000 91 13.2 – ADDENDUM NO. 2

- A. Project Name: Pacific Building Conversion
- B. Owner: Kitsap County Department of Human Services
- C. Architect: Rice Fergus Miller, Inc.
- D. Architect Project Number: 2021056.01
- E. Date of Addendum: November 29, 2023

FLOOR PLAN - FOUNDATION
SCALE: 1/8"=1'-0"

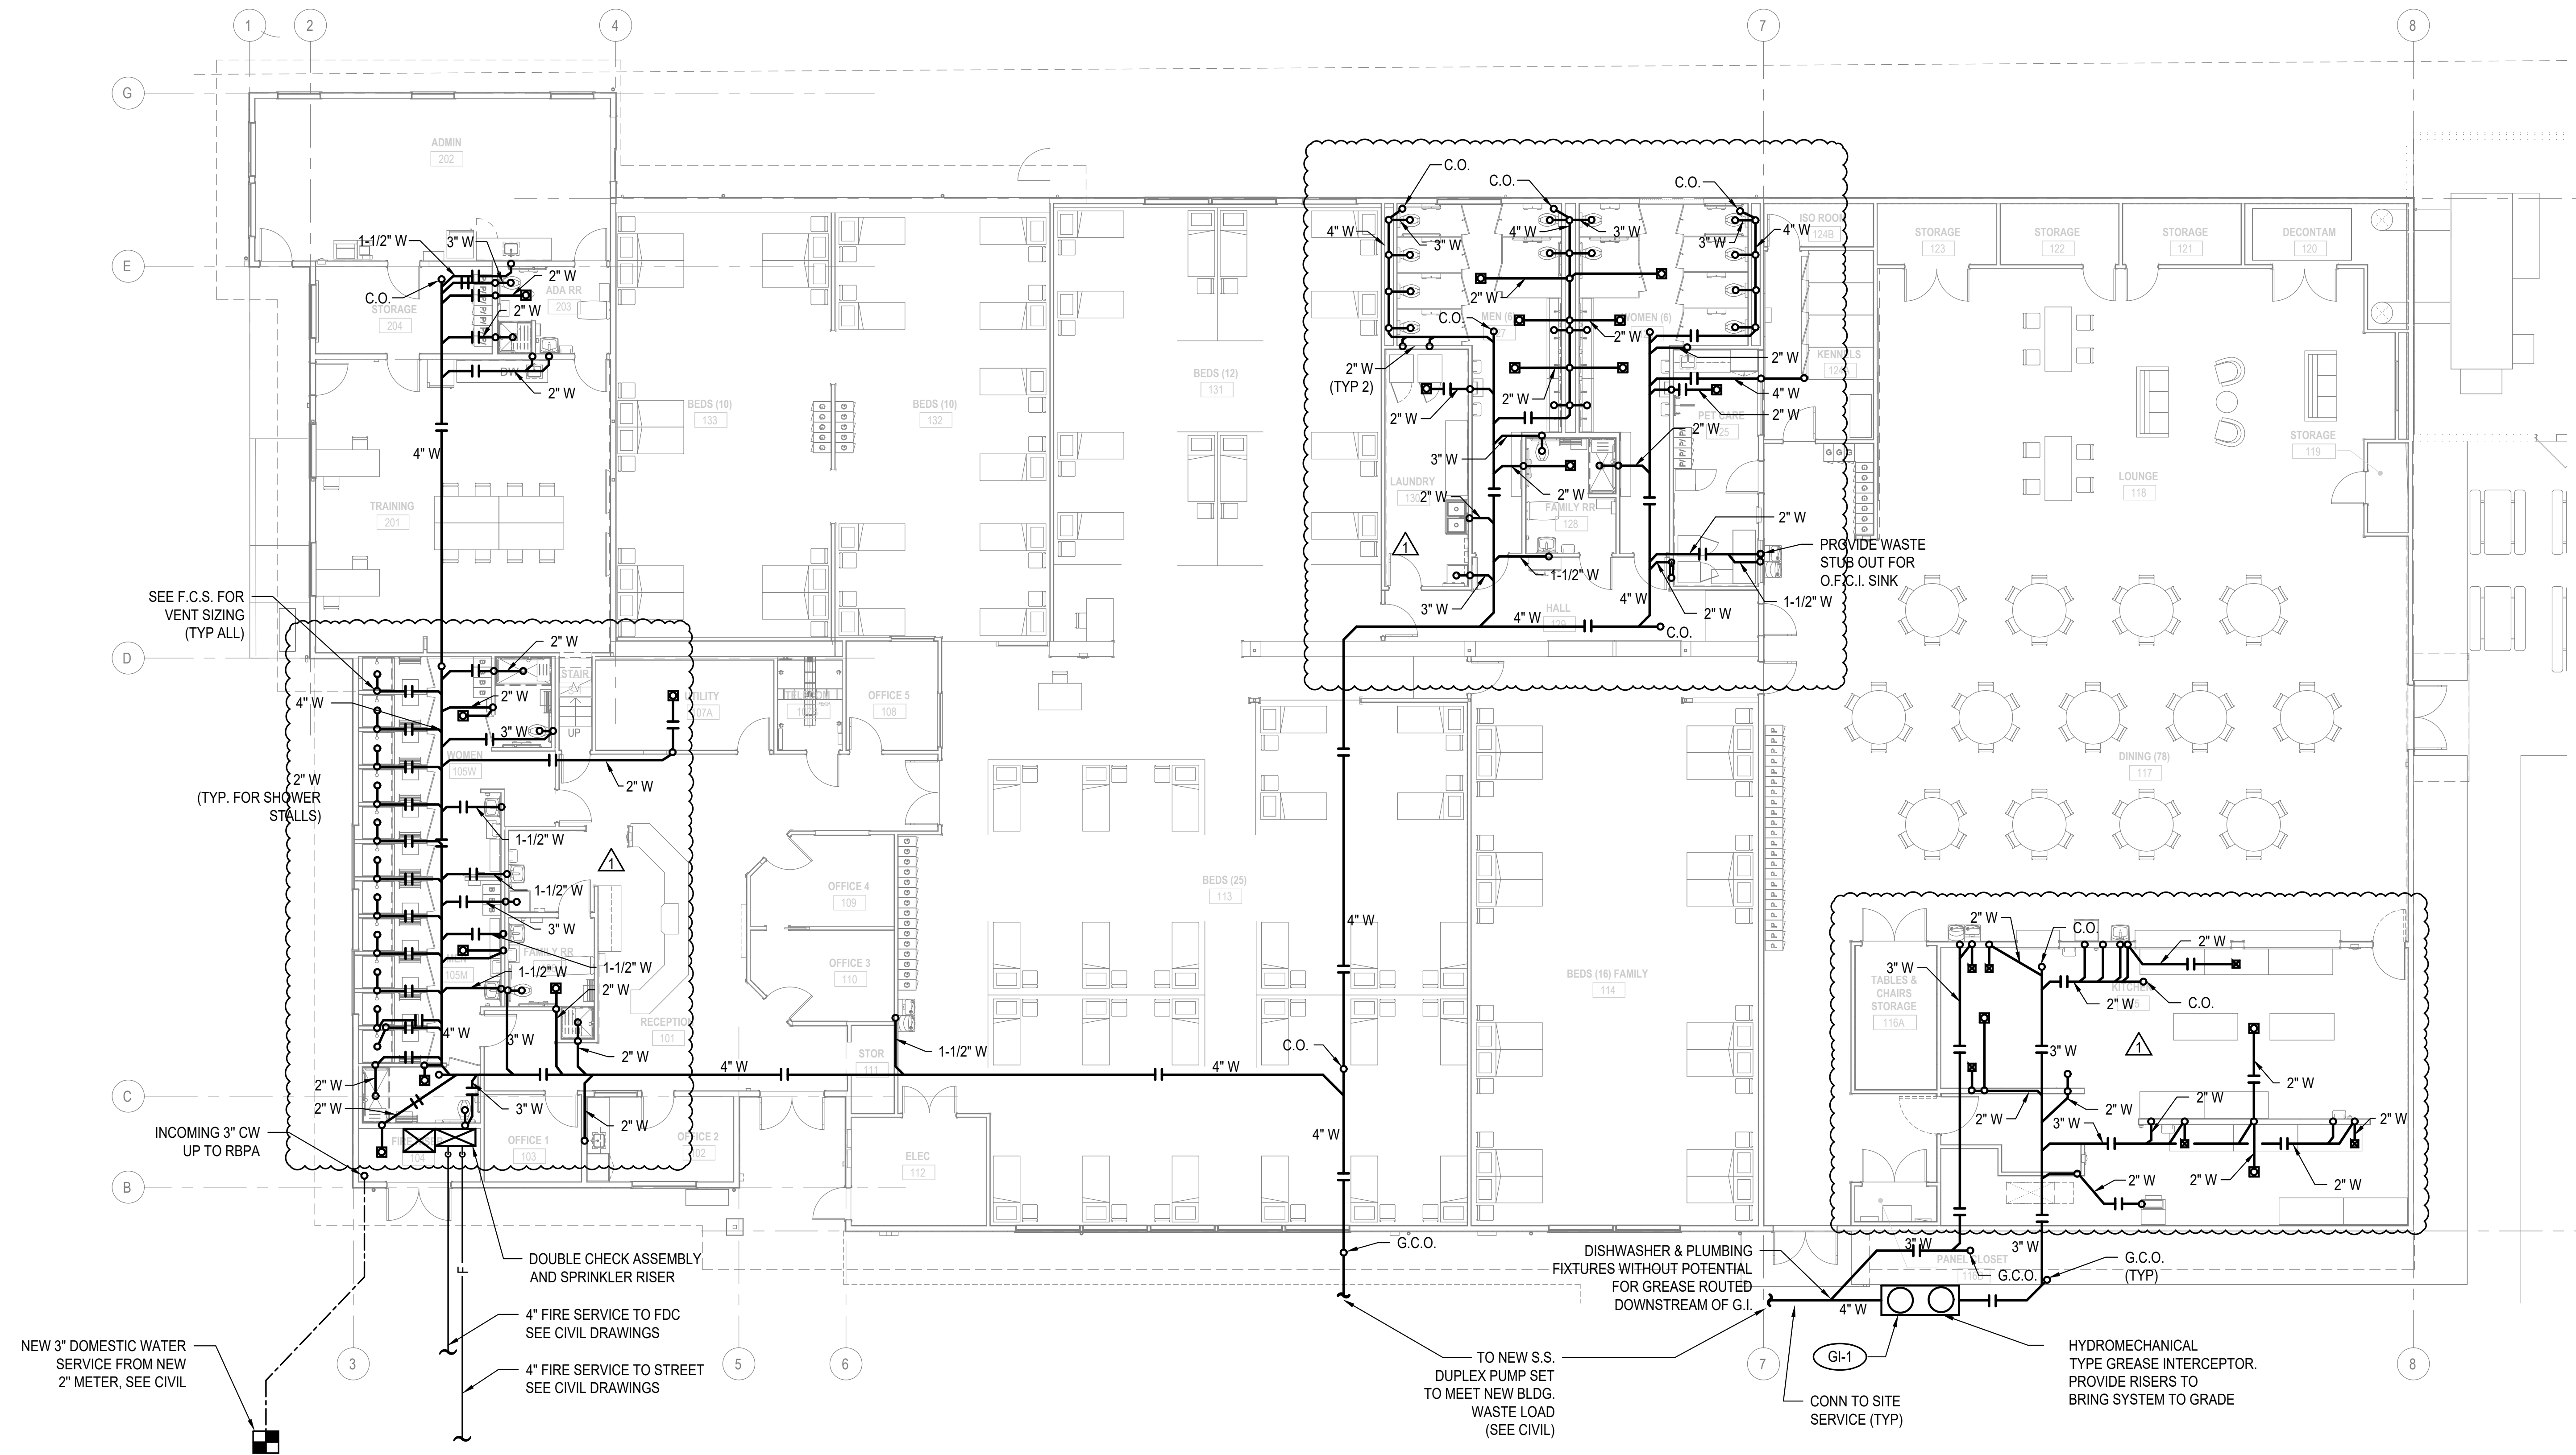
- a. Waste and vent routing updated. Floor sinks added to the kitchen.
- ITEM 17. Sheet P23.01 – Venting updated to match underground.
- ITEM 18. Sheet E00.03 – REPLACE in its entirety:
